8 November 2018

Re: Tritton Mine – DA 41/98 Modification 6 – Response to EPA Comments

Table 1
Updated Deposited Dust Monitoring 2014 – 2018

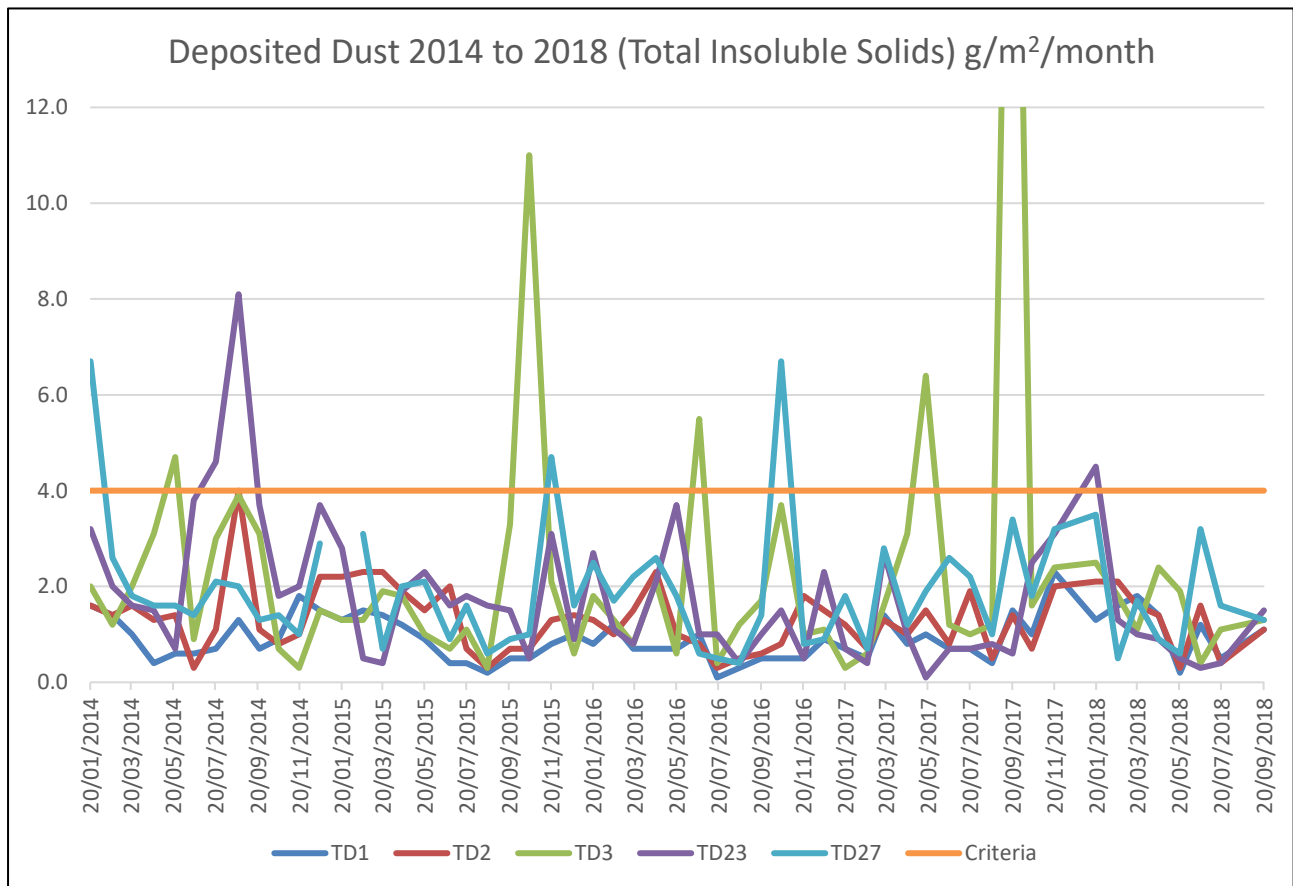
Clarification of the monthly data for the deposition of dust for the 2014-2017 period outlined in Table 12

The relevant criteria for deposited dust is the annual average (12 months) of the monthly data specified in g/m²/month. Therefore, the data presented in the Environmental Assessment is entirely suitable for consideration of existing compliance. Regardless, **Table 1** presents the data collected for monitoring locations at boundary locations for the Tritton Mine. These locations are the most appropriate for consideration as they provide an indication of deposited dust levels leaving the site. A chart of the data is also provided and demonstrates the low number of monthly exceedances of the 12-month average criteria, especially at monitoring locations TD1 and TD2 that are to the north of the Tailings Storage Facility (TSF).
